## **Staff Changes**

This section covers changes proposed by Planning Staff to correct errors and to reflect changes in conversion philosophy based on discussions with the PHED Committee and the Planning Board.

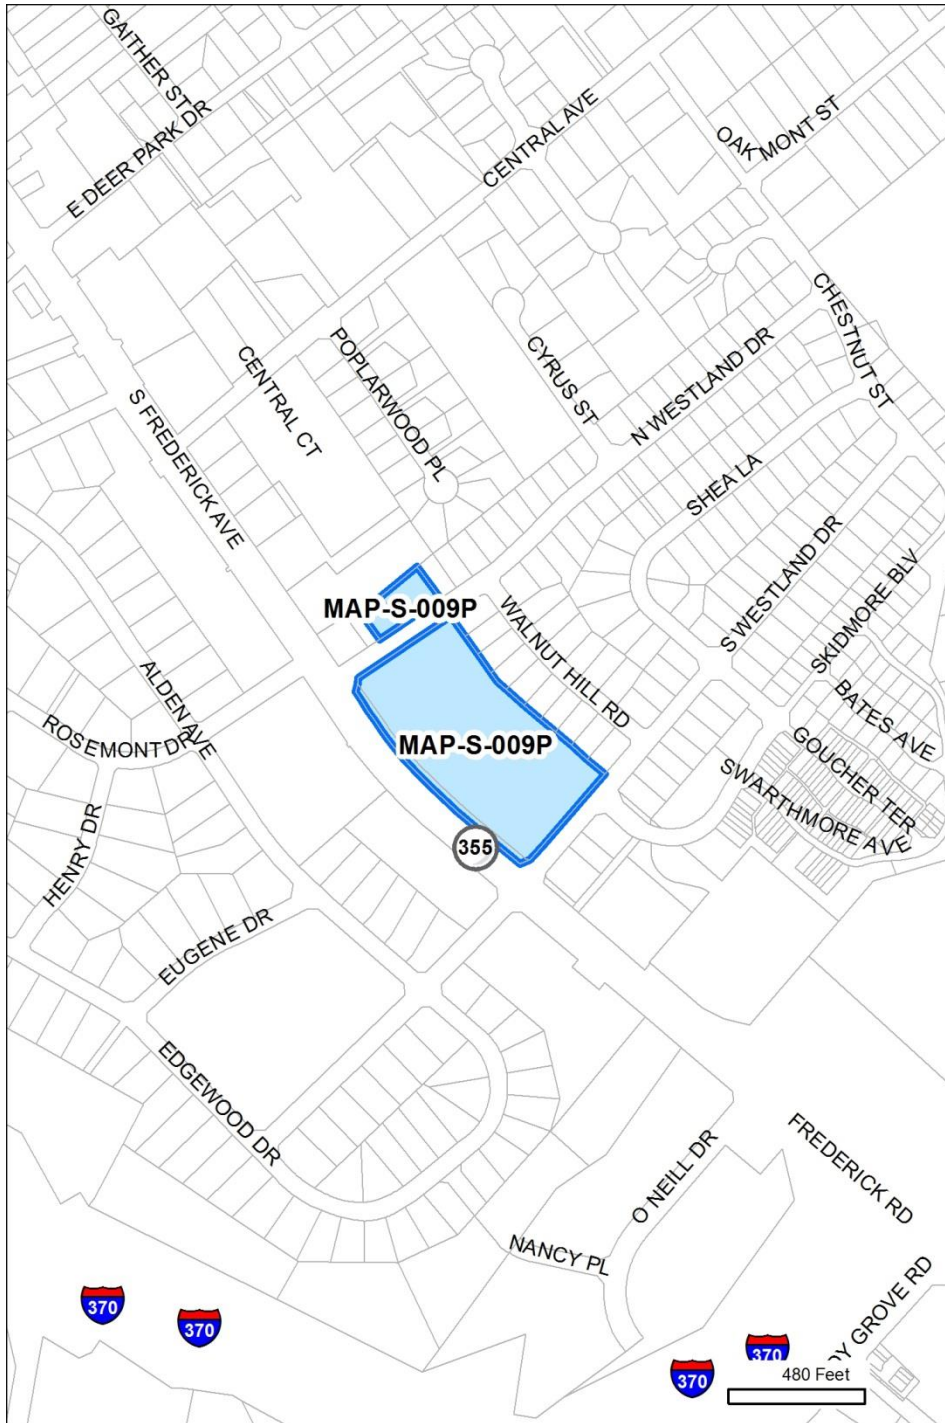
<b>Unique ID:</b> MAP-S-009P		staff rec. change
<b>Master Plan ID:</b> n/a		
<b>Master Plan:</b>	Great Seneca Science Corridor	
<b>Location:</b>	NE, SE corners 355 at Westland Dr	
<b>Existing Zone:</b>	C-2	
<b>Proposed Conv:</b> (5/2)	CRT-2.5 C-1.5 R-1.5 H-75	
<b>Prop. Revised Conv:</b>	CRT-2.25 C-1.5 R-0.75 H-75	
<b>Category:</b>	Staff Recommendation	
<b>Modifications</b>	<b>Zone Group:</b>	No change
	<b>Overall FAR:</b>	Reduced to 2.25
	<b>Comm'l FAR:</b>	No change
	<b>Resid'l FAR:</b>	Reduced to 0.75
	<b>Height:</b>	No change
<b>Reason for change:</b>		
<p>Since the 5/2 conversion, further staff analysis indicated that residential development in the C-2 zone is essentially limited to around 0.75 FAR. As a result, the Planning Board recommended reducing allowed residential FAR to 0.75, following its review of DMA-956. The PHED Committee agrees with this recommendation.</p> <p>With the reduction in maximum residential FAR, the total FAR allowed must be reduced to 2.25 FAR.</p>

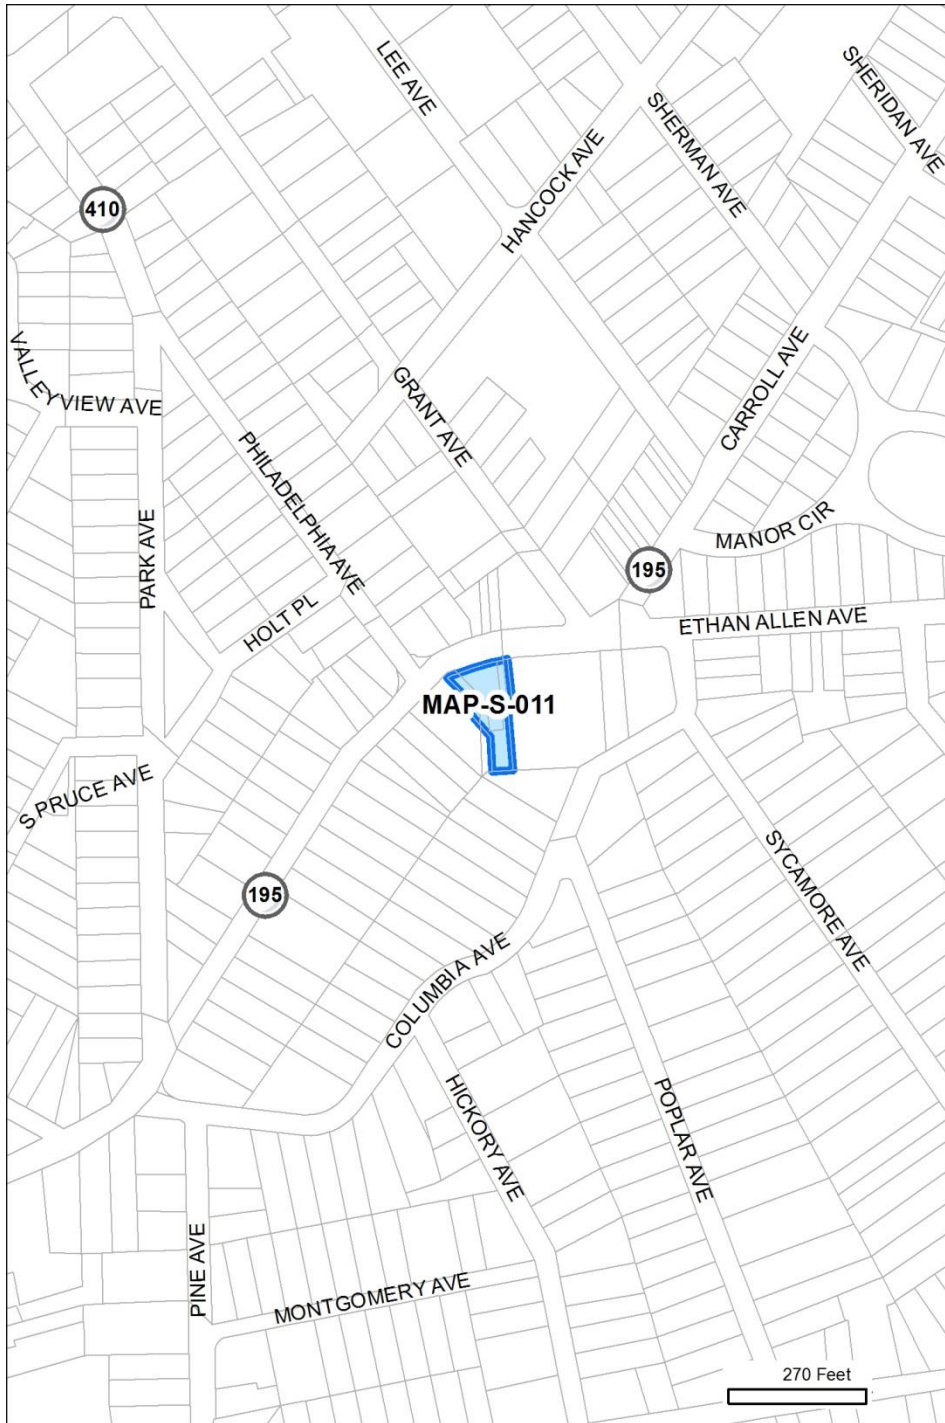
<b>Unique ID:</b> MAP-S-011		staff rec. change
<b>Master Plan ID:</b> 5		
<b>Master Plan:</b>	Takoma Park	
<b>Location:</b>	Carroll Avenue	
<b>Proposed Conv:</b> (5/2)	CRT-1.5 C-1.5 R-1.0 H-50	
<b>Prop. Revised Conv:</b>	CRT-1.5 C-1.5 R-0.75 H-50	
<b>Category:</b>	Staff Recommendation	
<b>Modifications</b>	<b>Zone Group:</b>	No change
	<b>Overall FAR:</b>	No change
	<b>Comm'l FAR:</b>	No change
	<b>Resid'l FAR:</b>	Reduced to 0.75
	<b>Height:</b>	No change
<b>Reason for change:</b>		
<p><i>Since the 5/2 conversion, further staff analysis indicated that residential development in the C-2 zone is essentially limited to around 0.75 FAR. As a result, the Planning Board recommended reducing allowed residential FAR to 0.75, following its review of DMA-956. The PHED Committee agrees with this recommendation.</i></p>

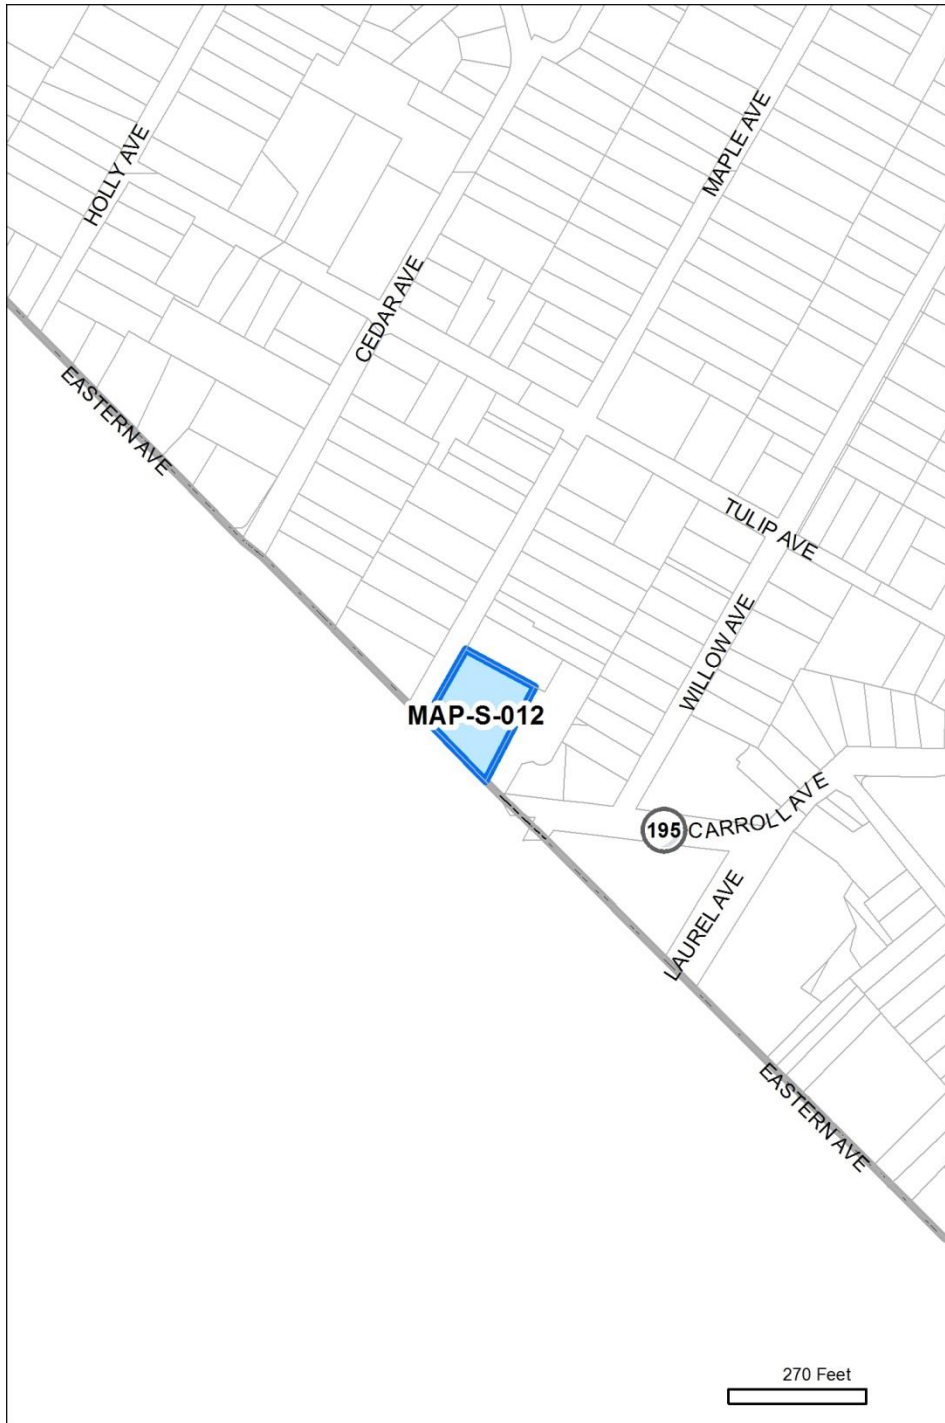
<b>Unique ID:</b> MAP-S-012		staff rec. change
<b>Master Plan ID:</b> 1		
<b>Master Plan:</b>	Takoma Park	
<b>Location:</b>	Carroll Avenue	
<b>Existing Zone:</b>	C-2	
<b>Proposed Conv:</b> (5/2)	CRT-2.0 C-1.5 R-1.0 H-50	
<b>Prop. Revised Conv:</b>	CRT-2.0 C-1.5 R-0.75 H-50	
<b>Category:</b>	Staff Recommendation	
<b>Modifications</b>	<b>Zone Group:</b>	No change
	<b>Overall FAR:</b>	No change
	<b>Comm'l FAR:</b>	No change
	<b>Resid'l FAR:</b>	Reduced to 0.75
	<b>Height:</b>	No change
<b>Reason for change:</b>		
<p>Since the 5/2 conversion, further staff analysis indicated that residential development in the C-2 zone is essentially limited to around 0.75 FAR. As a result, the Planning Board recommended reducing allowed residential FAR to 0.75, following its review of DMA-956. The PHED Committee agrees with this recommendation.</p>

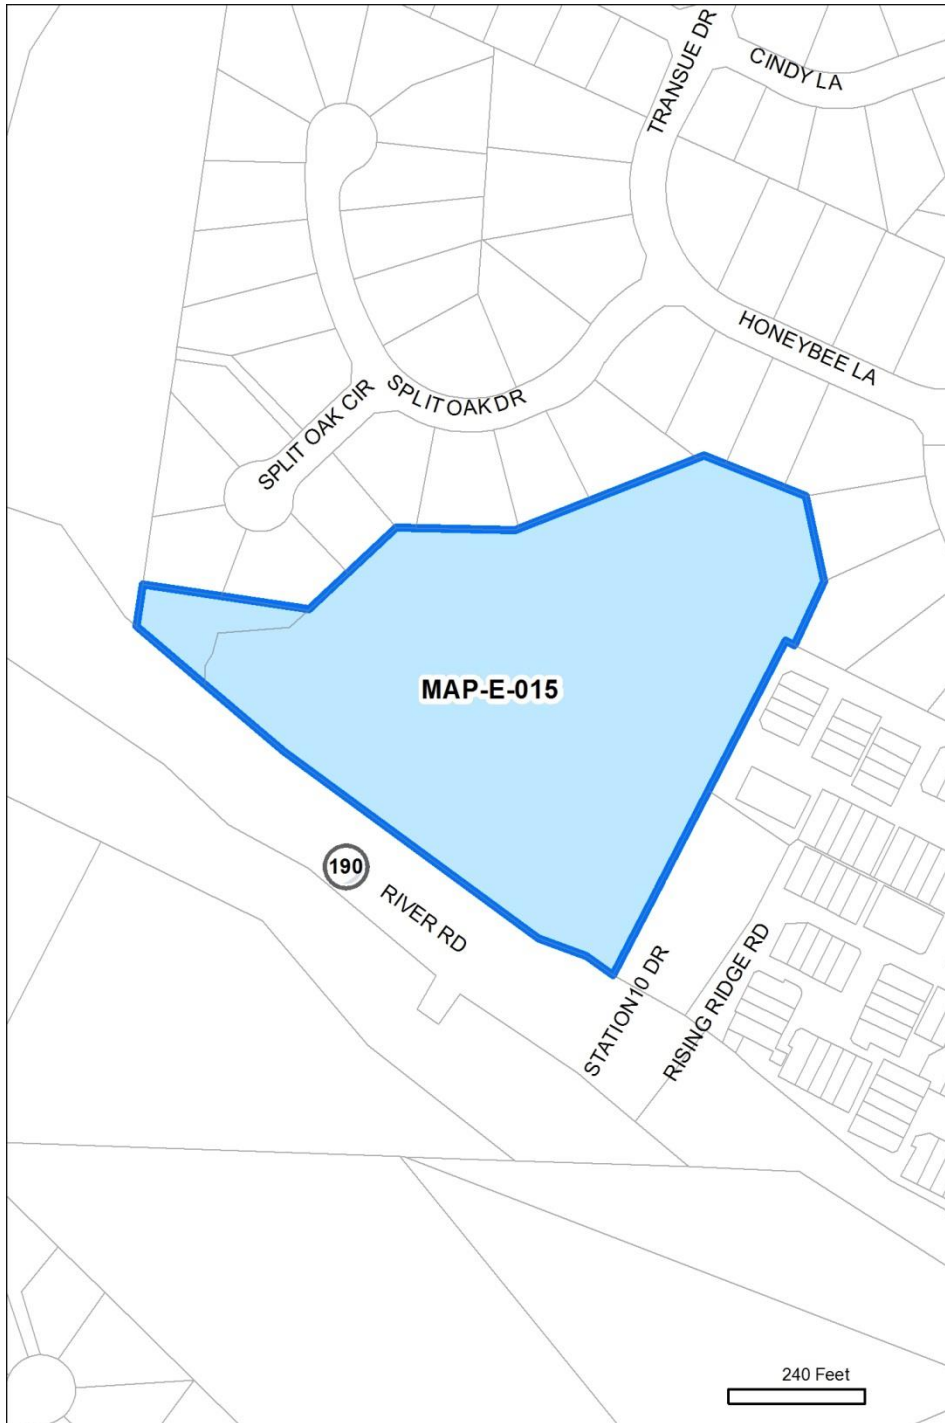
<b>Unique ID:</b> MAP-E-015		staff rec. change
<b>Master Plan ID:</b> 7		
<b>Master Plan:</b>	Potomac	
<b>Location:</b>	Former stone quarry on River Road at Station 10 Dr	
<b>Existing Zone:</b>	RMX-1/TDR	
<b>Proposed Conv: (5/2)</b>	<del>CRT-0.5 C-0.25 R-0.25 H-60 T</del>	
<b>Prop. Revised Conv:</b>	CRT-0.5 C-0.25 R-0.5 H-60 T	
<b>Category:</b>	Staff Error	
<b>Modifications</b>	<b>Zone Group:</b>	No change
	<b>Overall FAR:</b>	No change
	<b>Comm'l FAR:</b>	No change
	<b>Resid'l FAR:</b>	Increased to 0.5
	<b>Height:</b>	No change
<b>Reason for change:</b>		
<p><i>The 5/2 conversion gave this site a residential FAR of 0.25. Upon further review, staff determined that this was not enough to accommodate the residential density envisioned in the Master Plan.</i></p> <p><i>The Master Plan recommends a maximum density of 97 units, which has an estimated FAR of 0.38 for this site. Staff recommends changing permitted residential density to 0.5.</i></p>

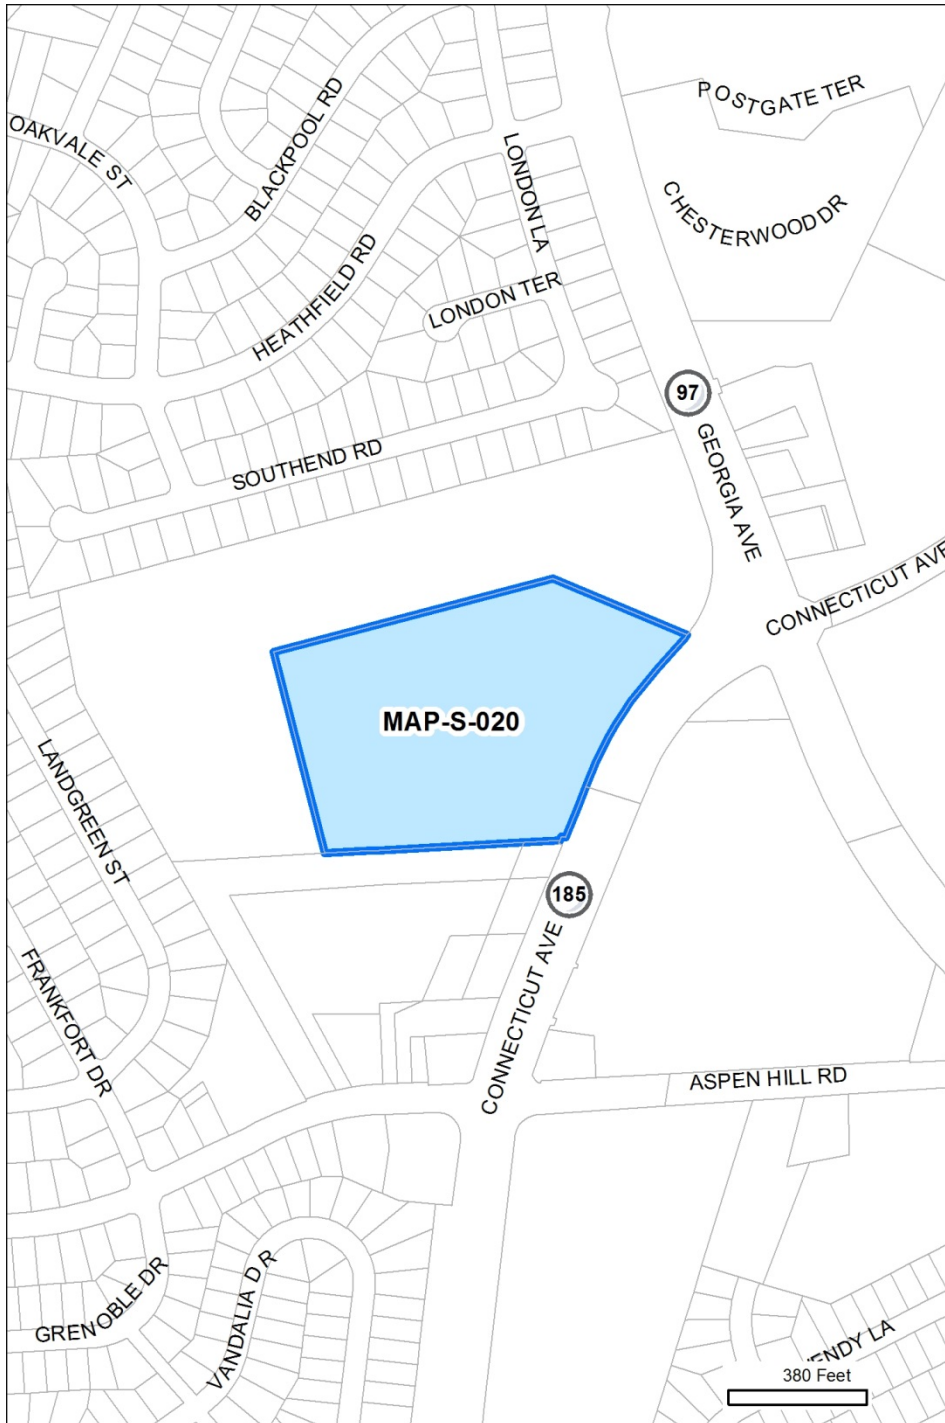
<b>Unique ID:</b> MAP-S-020		staff rec. change
<b>Master Plan ID:</b> 1		
<b>Master Plan:</b>	Aspen Hill	
<b>Location:</b>	Connecticut at Georgia	
<b>Existing Zone:</b>	RMX-2C	
<b>Proposed Conv: (5/2)</b>	EOF-2.0-H-65-T	
<b>Prop. Revised Conv:</b>	CRT-2.0 C-0.5 R-1.5 H-65 T	
<b>Category:</b>	Staff Recommendation	
<b>Modifications</b>	<b>Zone Group:</b>	Changed to CRT
	<b>Overall FAR:</b>	No change
	<b>Comm'l FAR:</b>	Created at 0.5
	<b>Resid'l FAR:</b>	Created at 1.5
	<b>Height:</b>	No change
<b>Reason for change:</b>		
<p><i>The 5/2 conversion called for converting this property to EOF, since the Master Plan envisioned office uses here. However, the default conversion for this property won't preclude office development, and staff feels that the default conversion is appropriate for this property.</i></p>

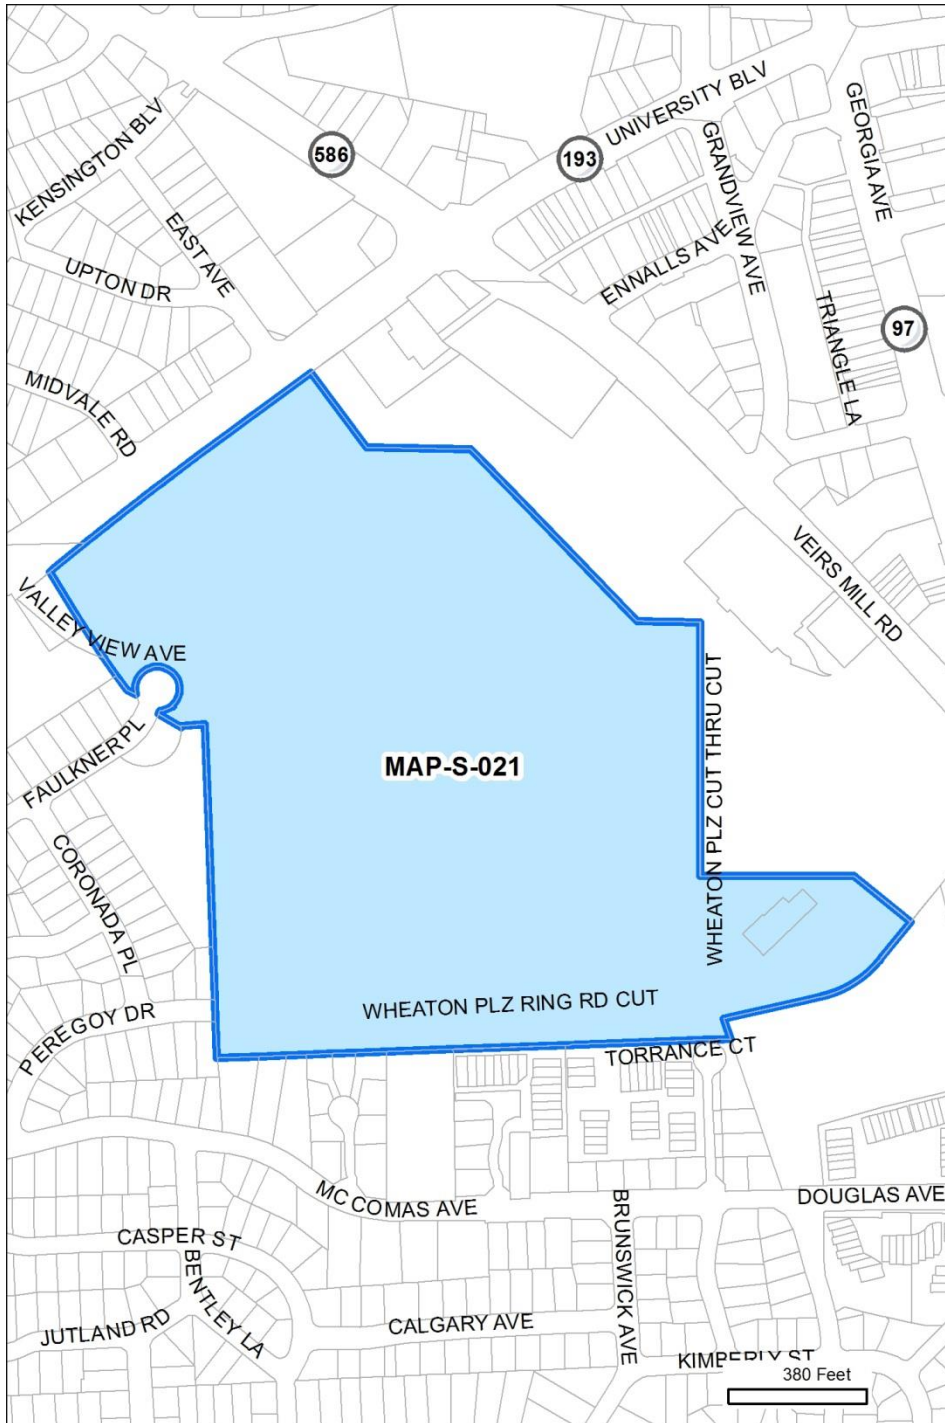
<b>Unique ID:</b> MAP-S-021		staff rec. change
<b>Master Plan ID:</b> 1		
<b>Master Plan:</b>	Wheaton CBD	
<b>Location:</b>	Wheaton Plaza	
<b>Existing Zone:</b>	C-2	
<b>Proposed Conv: (5/2)</b>	GR-1.5 H-130	
<b>Prop. Revised Conv:</b>	GR-2.5 H-75	
<b>Category:</b>	Staff Recommendation/Staff Error	
<b>Modifications</b>	<b>Zone Group:</b>	No change
	<b>Overall FAR:</b>	Increased to 2.5
	<b>Comm'l FAR:</b>	-
	<b>Resid'l FAR:</b>	-
	<b>Height:</b>	Decreased to 75'
<b>Reason for change:</b>		
<p><i>The current Zoning ordinance text allows C-2 zones to go to 75' in height and 2.5 in FAR for mixed-use projects. A footnote allows some structures up to 130' in height at regional mall sites.</i></p> <p><i>The additional height is codified in the Regional Shopping Center Overlay zone. Height for all other C-2 properties is limited to 75'.</i></p> <p><i>The FAR was listed at 1.5 in error in the 5/2 draft.</i></p>

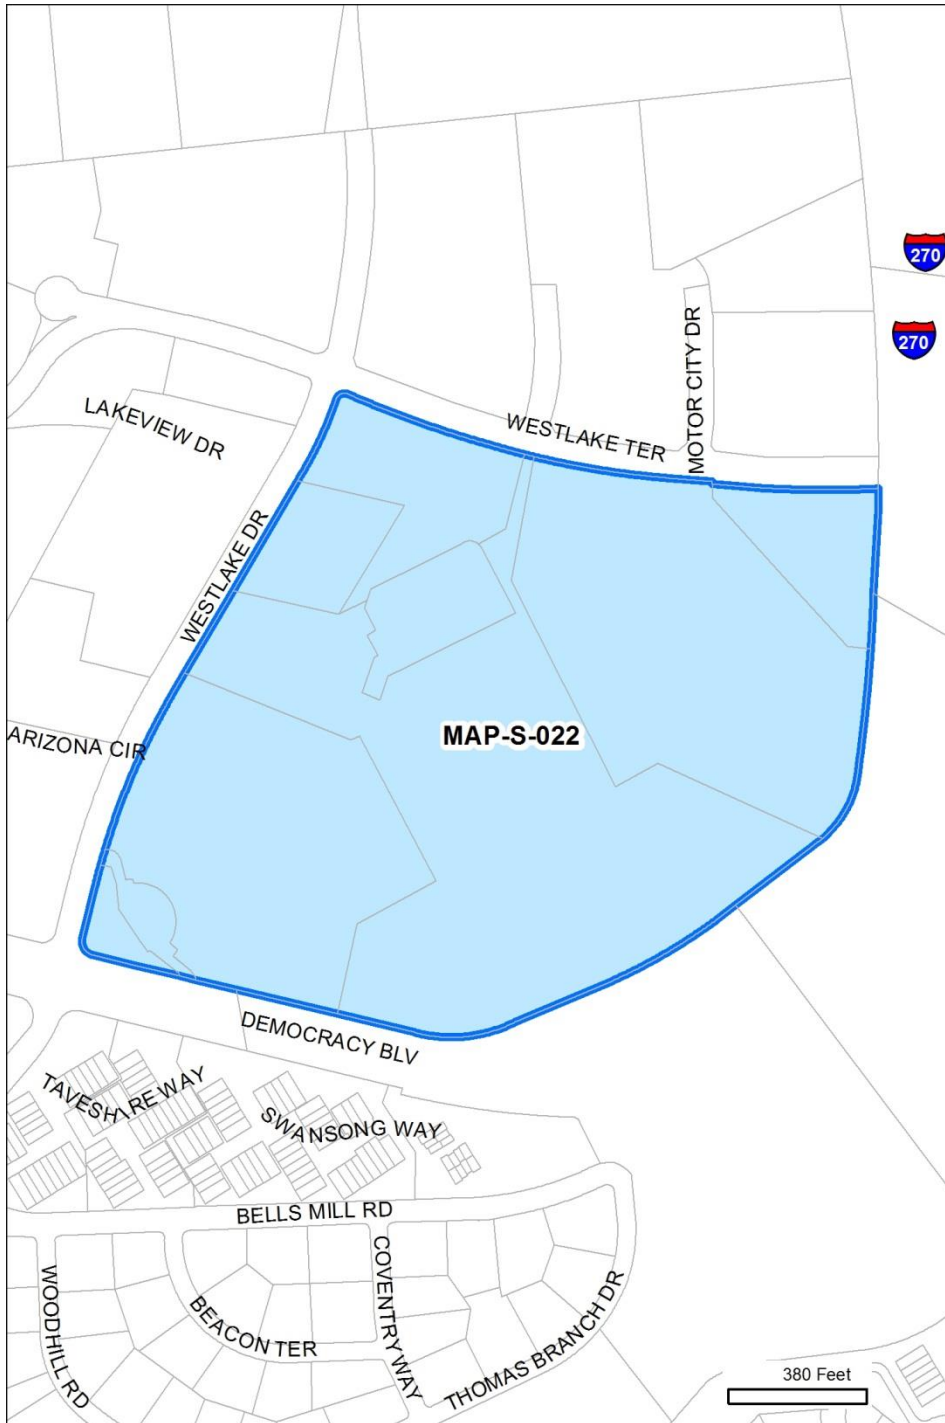
<b>Unique ID:</b> MAP-S-022		staff rec. change
<b>Master Plan ID:</b> 8		
<b>Master Plan:</b>	Potomac Subregion	
<b>Location:</b>	Montgomery Mall	
<b>Existing Zone:</b>	C-2	
<b>Proposed Conv:</b> (5/2)	GR-2.5 H-130	
<b>Prop. Revised Conv:</b>	GR-2.5 H-75	
<b>Category:</b>	Staff Recommendation	
<b>Modifications</b>	<b>Zone Group:</b>	No change
	<b>Overall FAR:</b>	No change
	<b>Comm'l FAR:</b>	-
	<b>Resid'l FAR:</b>	-
	<b>Height:</b>	Decreased to 75'
<b>Reason for change:</b>		
<p><i>in height and 2.5 in FAR for mixed-use projects. A footnote allows some structures up to 130' in height at regional mall sites.</i></p> <p><i>The additional height is codified in the Regional Shopping Center Overlay zone. Height for all other C-2 properties is limited to 75'.</i></p>
